**Application for Minor Amendments
to Reserved Matters Approval
For Building T5 2013/2481/P**

King's Cross Central General Partner Ltd
Aga Khan Foundation (United Kingdom)

December 2014

Drawing Title
General Arrangement
South Elevation

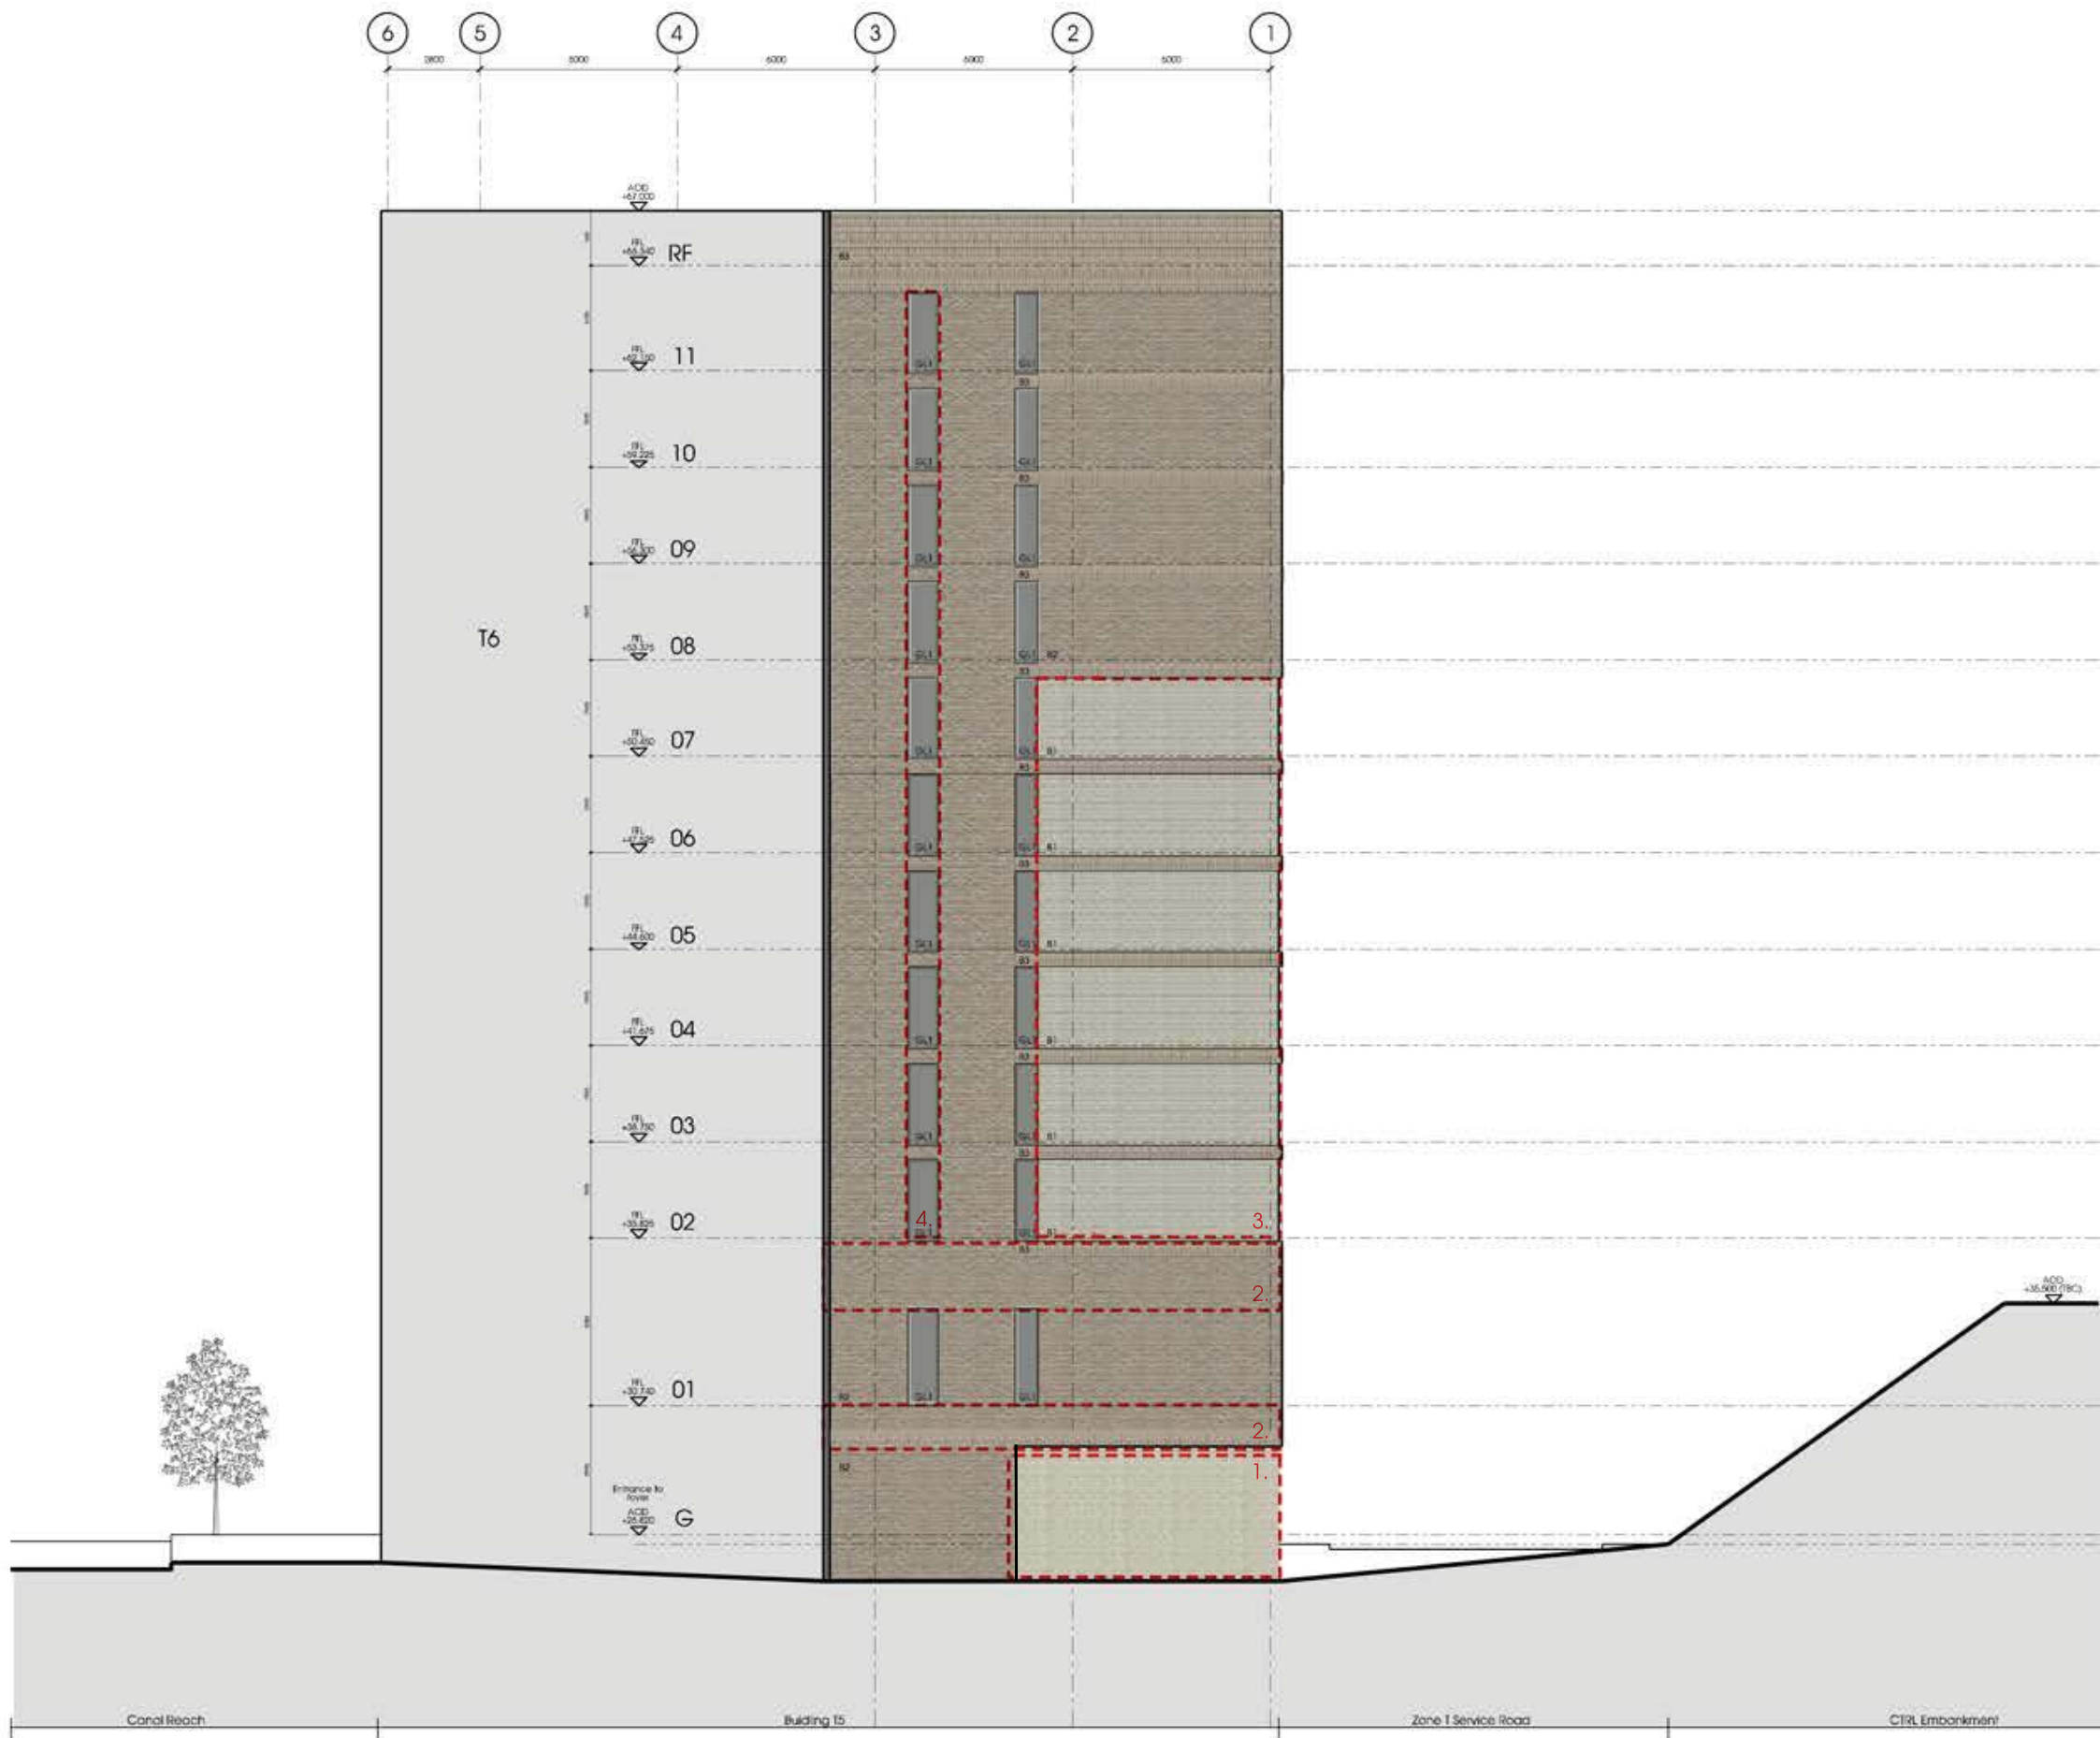
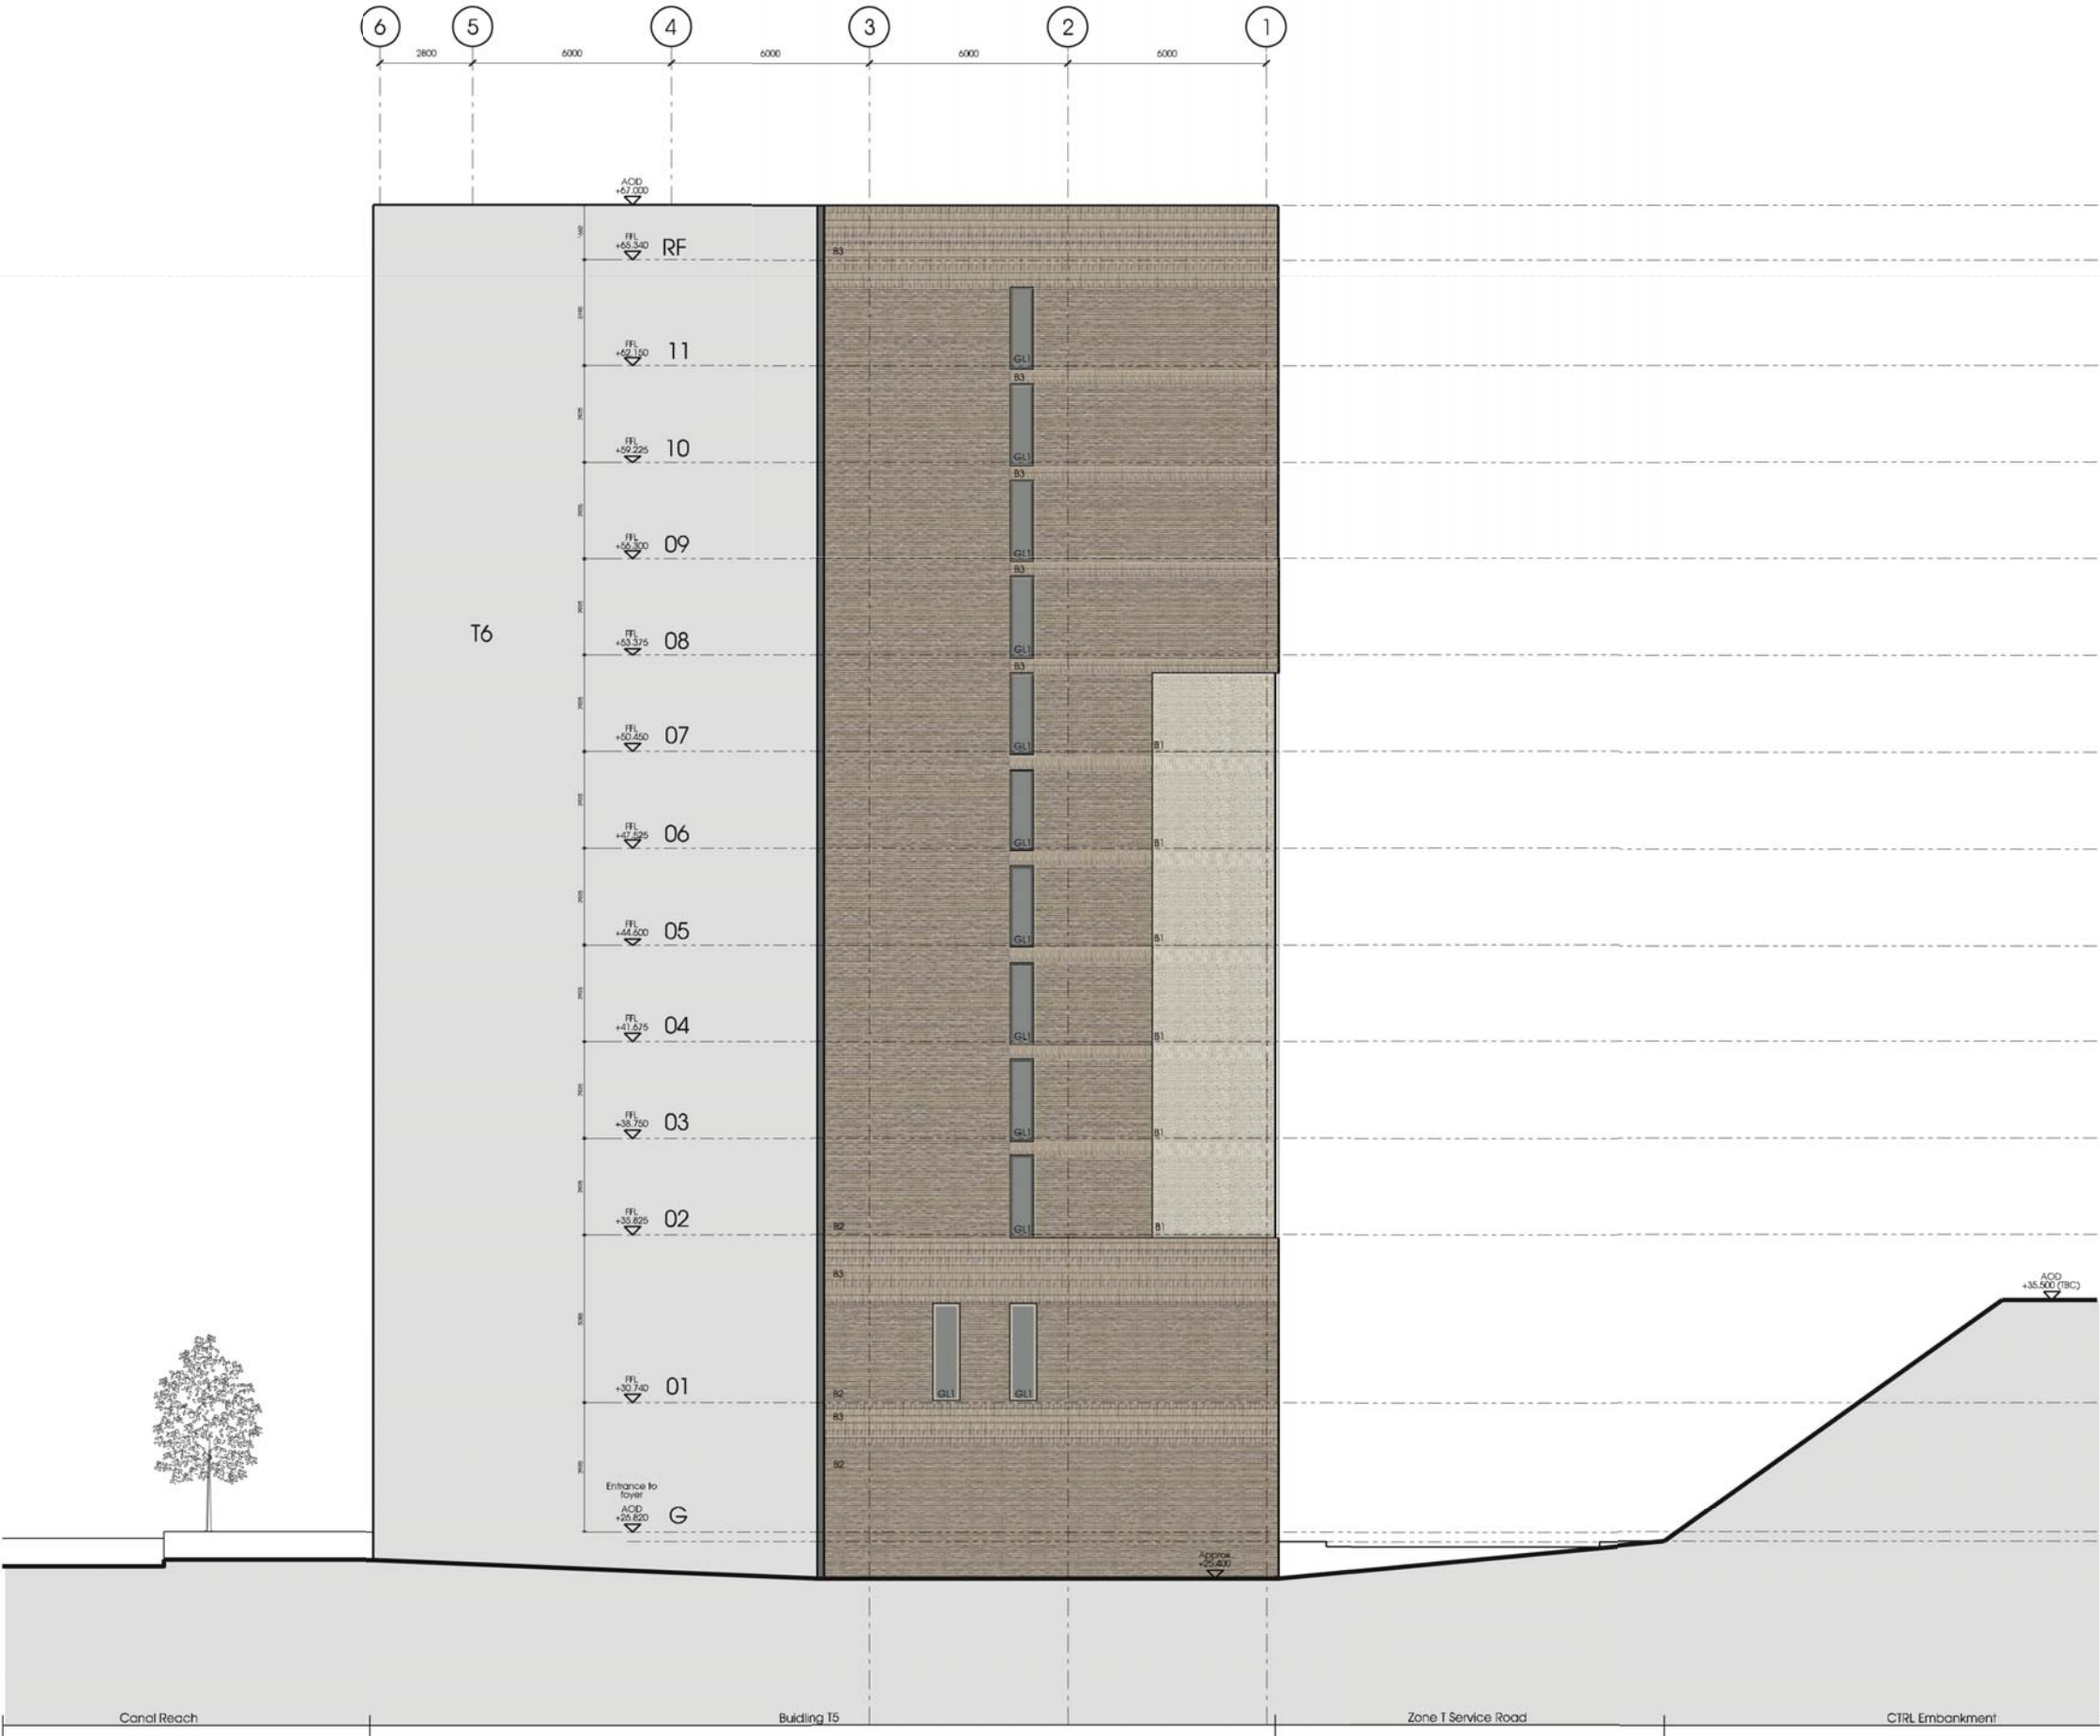
1. Realignment of commercial unit glazing
2. Soldier course brickwork added
3. Glazing set back
4. Reduction in glazing size South facade corridor windows from 1472 to 1135mm
5. Blind hit and miss brickwork replaced with soldier course brickwork

of the entrance doors has been revised also; a single door is now located centrally rather than at either end of the glazing. This is as a result of further review of possible future commercial unit arrangements. This is shown as amendment 1 on drawing 426 00_233 P0 submitted for information, and shown on drawing 426 00_233 P1 for approval.

An additional area of soldier course brickwork is located above the commercial unit at ground floor level; this is a continuation of this band along the northern elevation, and mirrors the treatment of the top of the east and west towers, creating a consistent approach to the termination of brickwork across all elevations. This is shown as amendment 2 on 426 00_233 P0 submitted for information, and shown on drawing 426 00_233 P1 for approval.

It is proposed that the glazing of the south facing elevation of the courtyard will also be set back from levels 02-07, consistent with the eastern and western facing elevations of the courtyard, and adding further articulation to the south elevation facing Canal Reach. These set-backs also create additional shading to glazing with a southerly aspect, further reducing solar gain and glare into bedrooms. This is amendment 3 on drawing 426 00_233 P0 submitted for information, and shown on drawing 426 00_233 P1 for approval.

There is a minor reduction of the size of the glazing along the eastern and western towers at level 02-11 of the southern elevation. This is annotated as as amendment 4 on drawing 426 00_233 P0 submitted for information, and shown on drawing 426 00_233 P1 for approval.

The band of blind 'hit and miss' brickwork along the facade at level 8, to the south of the level 08 terrace, has been replaced by a deep band of soldier course brickwork. This reflects the banding at the top of the east and west towers of the facade, and is consistent with the treatment of the northern elevation. This is shown as amendment 5 on 426 00_233 P0 submitted for information, and shown on drawing 426 00_233 P1 for approval.
